PROJECT: Summerlin West Village 22 - Kettle Bend Road
(Sunset Run Drive to Kestrel Creek Road)

SUBJECT: Drainage Study for:
Summerlin West Village 22 - Kettle Bend Road (Sunset Run Drive to Kestrel Creek Road)

Subject: **Supplement #1 to the Technical Drainage Study for Summerlin West Village 22 Kettle Bend Road**

SUBJECT: SUPPLEMENT #1 TO THE TECHNICAL DRAINAGE STUDY FOR SUMMERLIN WEST VILLAGE 22 KETTLE BEND ROAD (SUNSET RUN DRIVE TO KESTREL CREEK ROAD)

EXISTING CONDITION MAP
FIGURE 6

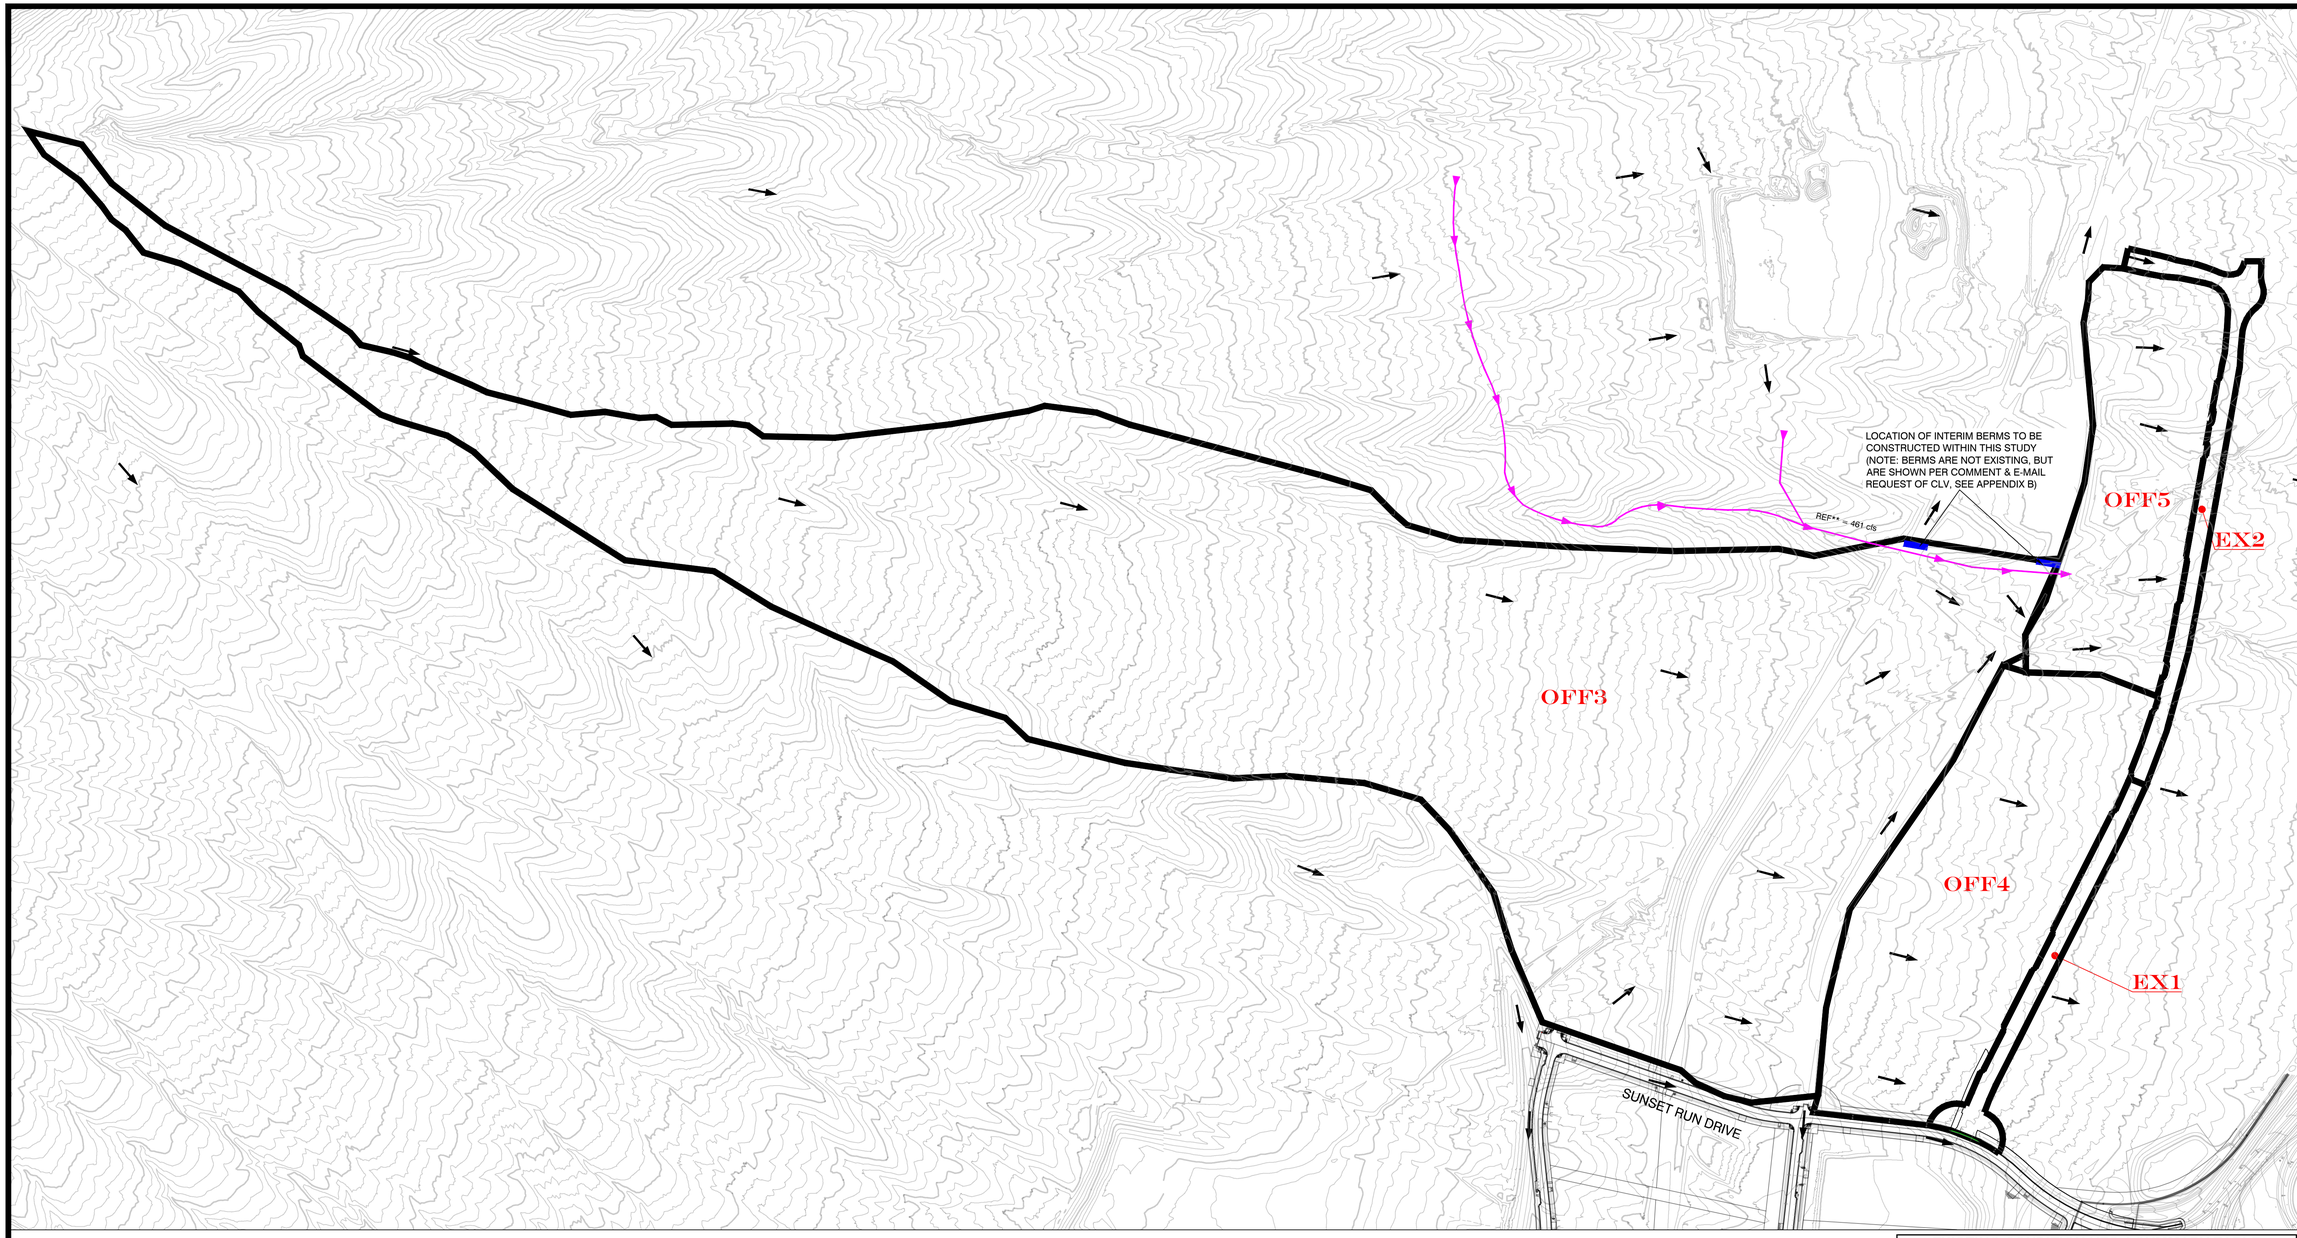
Previous Comments #9 & #10: Figure 6 (Existing Condition Map): The response stated that interim facilities have been proposed at the north boundary of offsite basin OFF3 in order to convey flow east instead of going north. However, the contours presented on the Existing Condition Map did not reflect such a facility. A mere callout of "Atkins Interim Flowline" is not acceptable. Coordinate with Atkins about the status of the proposed interim facility and incorporate on all pertinent drainage condition maps and improvement plans.

RESPONSE: Per City of Las Vegas request the two interim berm facilities at the north boundary of offsite basin OFF3 have been shown and labelled on *Figure 6: Existing Condition Basin*. However, as these are interim facilities being proposed within this study, it should be noted that the facilities do not actually exist in the existing condition, only the interim conditions. As acknowledged in the previous submittal, a portion of the flow in the existing condition will be redirected north in the existing swale before eventually recombining in the Gowan Lone Mountain Beltway System. Grading for the berms has been provided on plan sheet GR12. E-mail correspondence with CLV has been provided in Appendix B.

UTILITY PLAN 1
51+00 TO 54+00

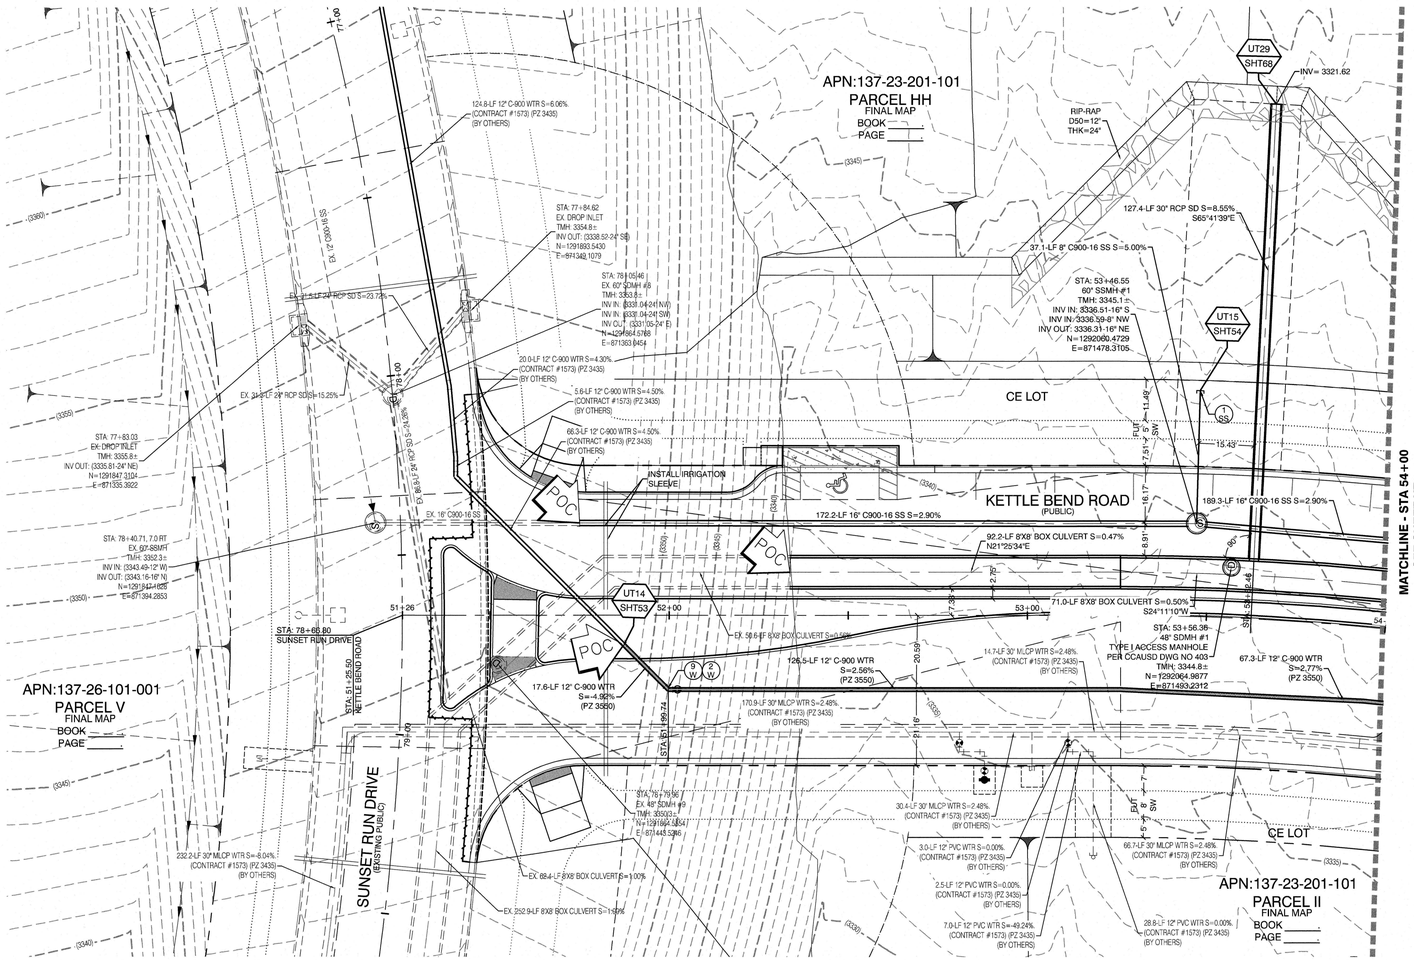
Previous Comment #17: Sheet UT1: Provide a note and connection detail between the new and existing 8'x8' regional box culvert.

A structural connection detail has not been provided in the last submittal.

RESPONSE: The RCB connection detail has been provided as Detail 1 on Sheet S1.

GRADING PLAN 12

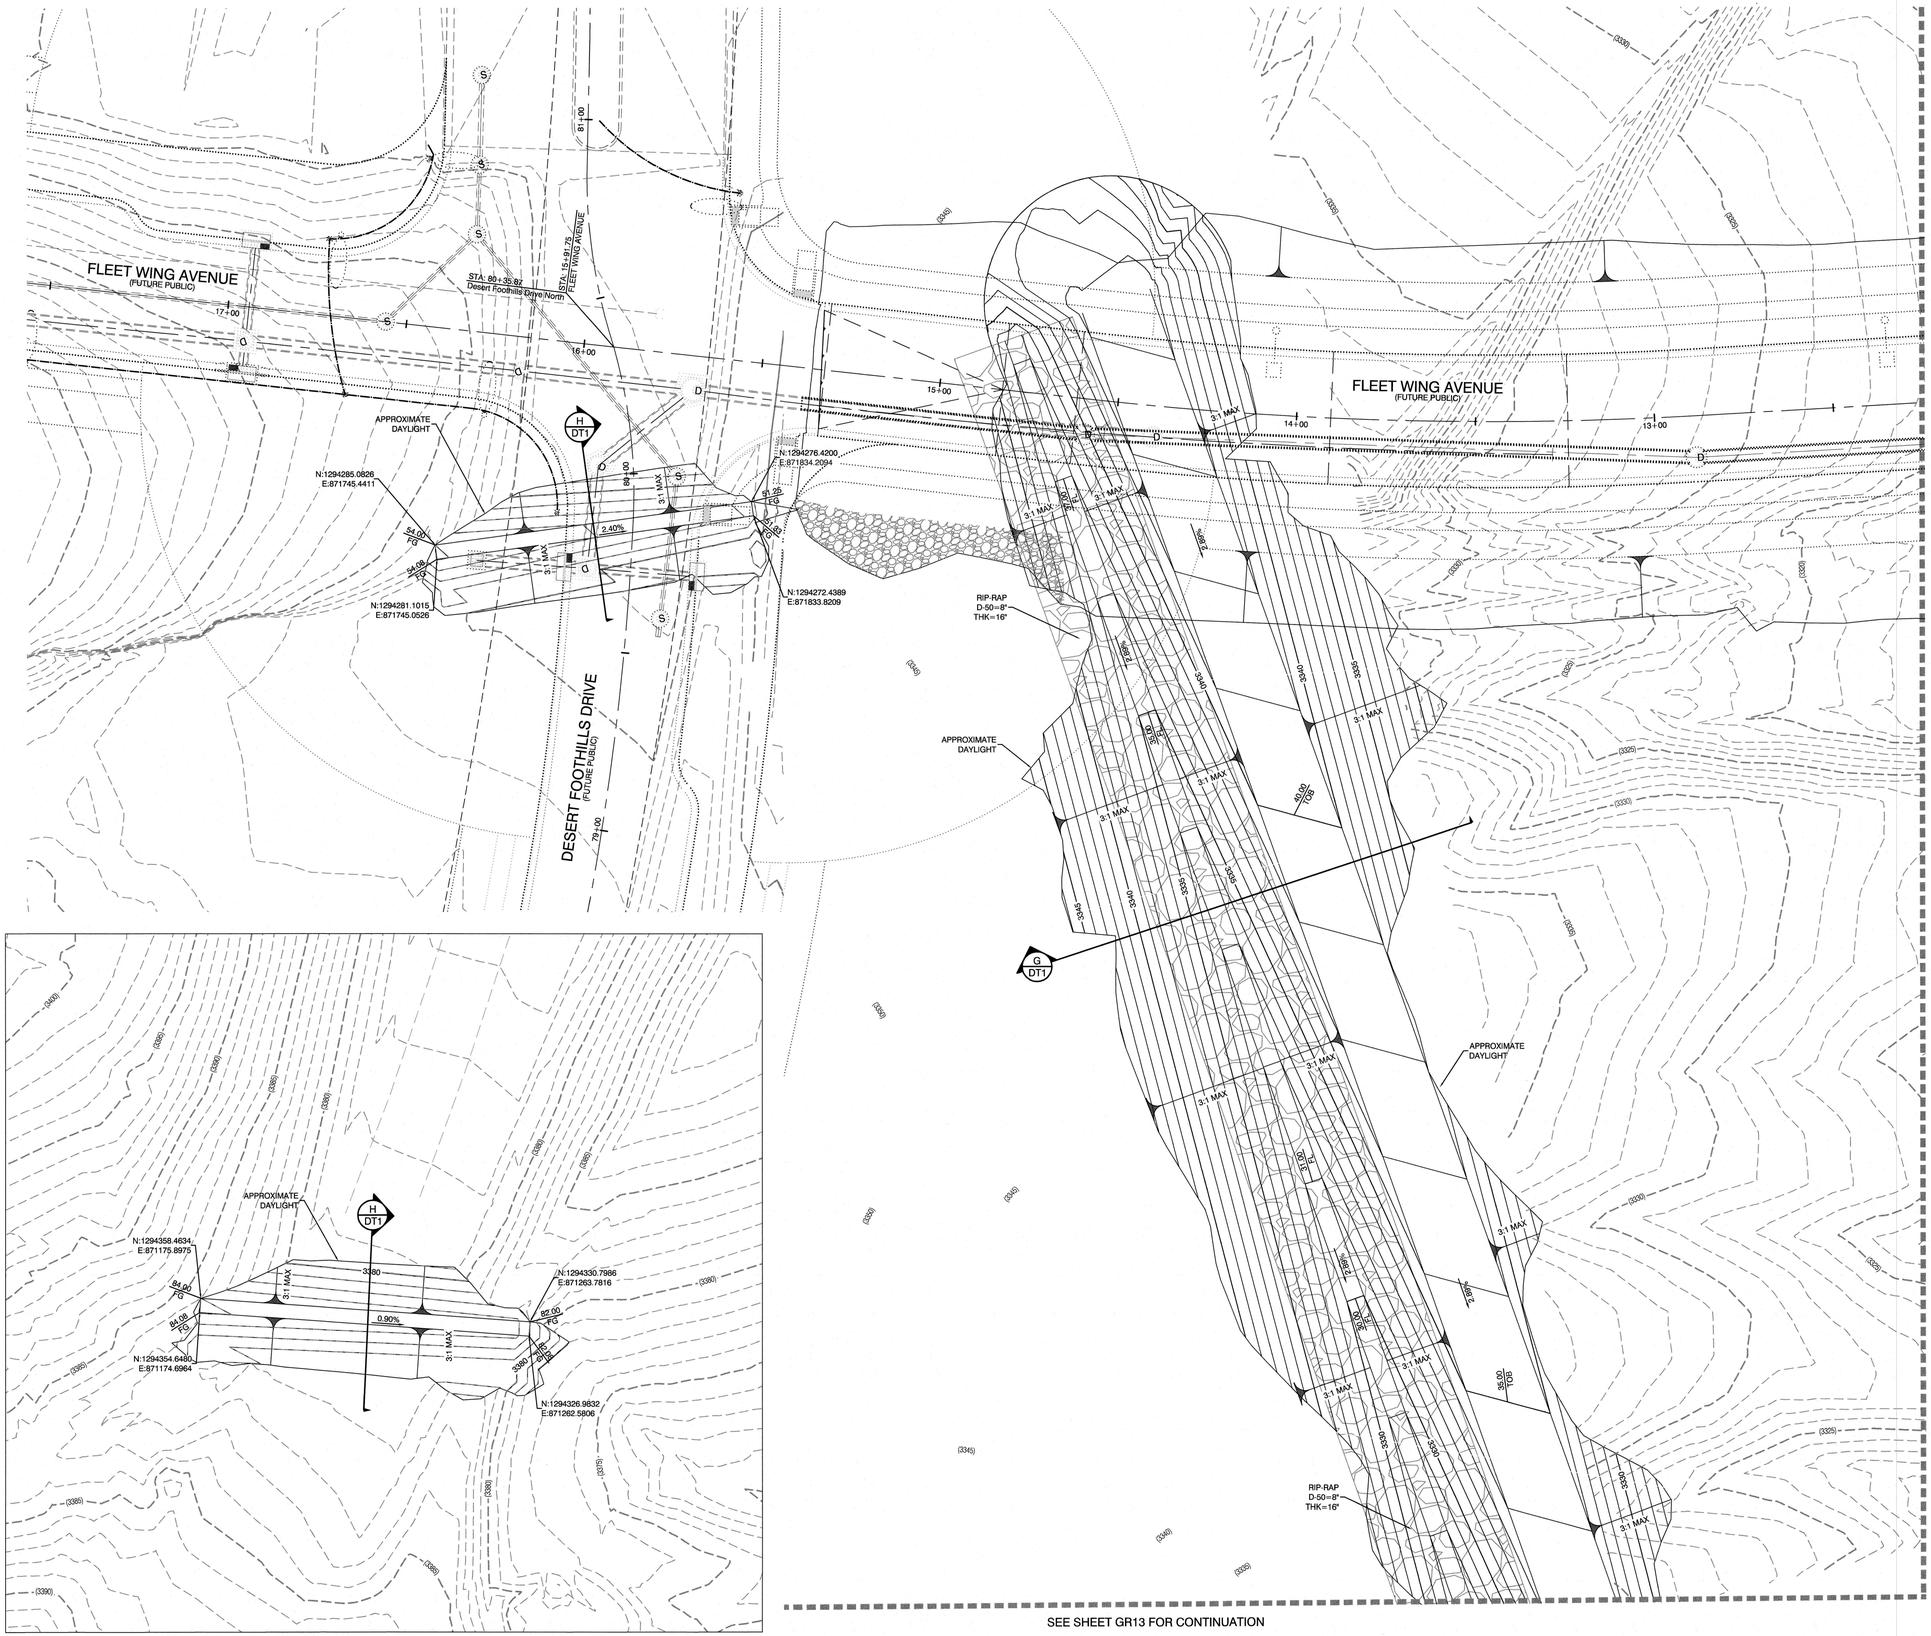
As you said, VTN is proposing the interim facilities as part of this study to convey the flow east, however, I didn't see this facility on the Existing Condition Map. You need to show this interim berm/channel on all pertinent drainage condition maps and improvement plans.

-Note VTN, not Atkins is proposing the interim facilities as part of this study to convey the flow east as shown on the interim condition maps and plan sheet GR12.
Please call me when you get the chance at 702-253-2431.
